BATTERY

Subject: new battery

Model: V11

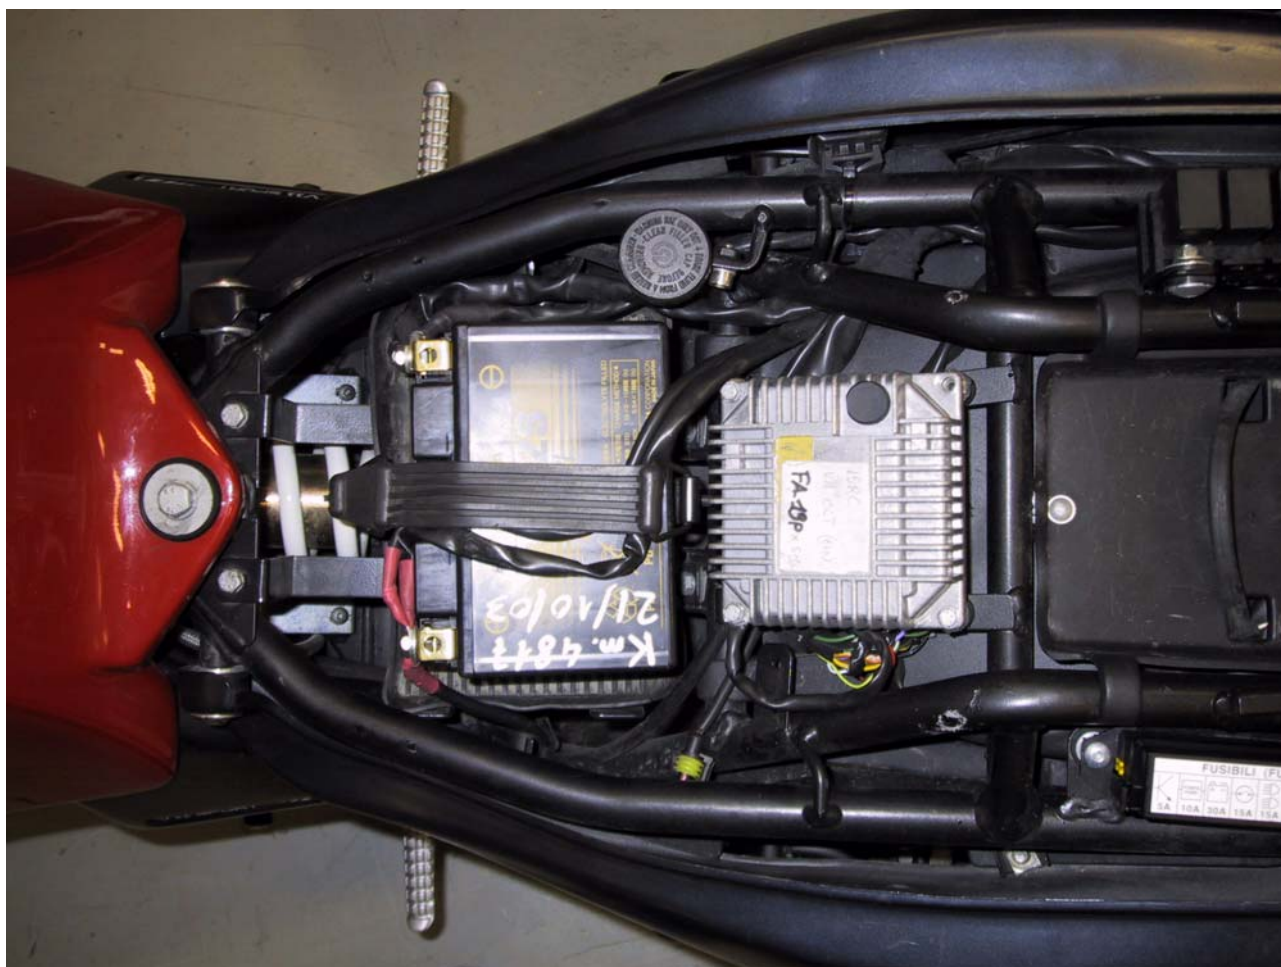
Problem:

short life-span of the presently fitted **ESA SPARK 500E** battery.

Solution in production:

the **YUASA YTZ12S** battery will be fitted (comes from Yuasa already filled with fluid).

In production is fitted a new wiring while on bikes with present wiring it is possible to fit the battery and re-route the cables.
